MANDATORY SERVICE BULLETIN

No. MSB-E4-022/5
SUPERSEDES MSB-E4-022/4

Waste Gate Control Rod.

Engine type: E4
Engine model(s): E4, E4P
Serial number(s): all

Figure 4: Waste Gate Circlip

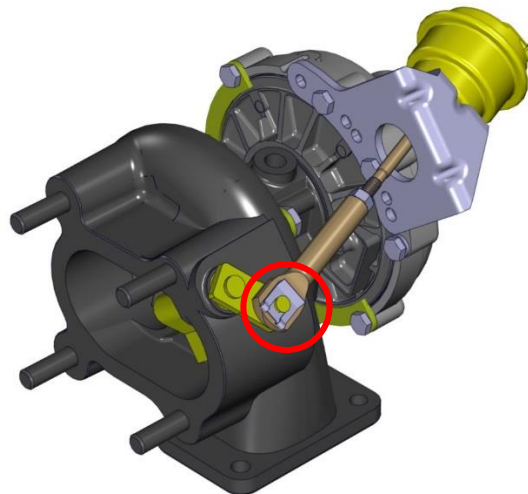
1. Make sure MM-TR-MDC-E4-386 and MM-TR-MDC-E4-399 are inserted into the Maintenance Manual or a revision of the Maintenance Manual with the Temporary Revisions incorporated is used.
2. Replace the waste gate controller according to Maintenance Manual section 81-00-33.
3. Install a new the spring loaded circlip E4A-41-100-801. Refer to figure 4

1. Replace the waste gate controller according to Maintenance Manual section 81-00-33.
2. Install a new the spring loaded circlip E4A-41-100-801. Refer to figure 4.

- Installing a waste-gate controller or a turbocharger with the waste-gate con-rod fail-safe bridge already installed is considered as accomplishment of the terminating action.
 - For new engines already produced with the waste-gate con-rod fail-safe bridge already installed, the terminating action may be recorded as completed.
1. Make sure MM-TR-MDC-E4-422 is inserted into the Maintenance Manual or a revision of the Maintenance Manual with the Temporary Revisions incorporated is used.
 2. If not yet installed, install a new spring loaded circlip E4A-41-100-801. Refer to figure 4.

Figure 5: Fire sensor bracket shims

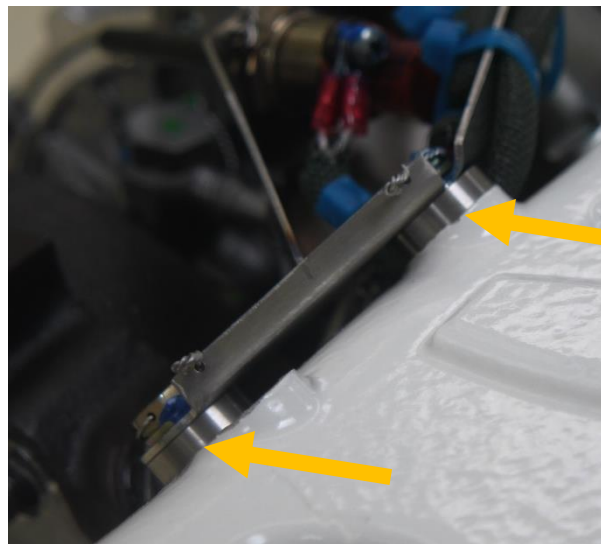
3. Install the waste-gate con-rod fail-safe bridge according to Maintenance Manual section 81-00-36 or install a waste-gate controller with the fail-safe con-rod bridge already installed. Make sure there is sufficient clearance to adjacent parts.
4. For twin engine installations only: If there is insufficient clearance between the waste-gate con-rod fail-safe bridge and the fire sensor bracket, shim between the fire sensor bracket and the injector cover with bushings BU2-20-08-0050-C. Refer to Figure 5 and the Airplane Maintenance Manual for installation.
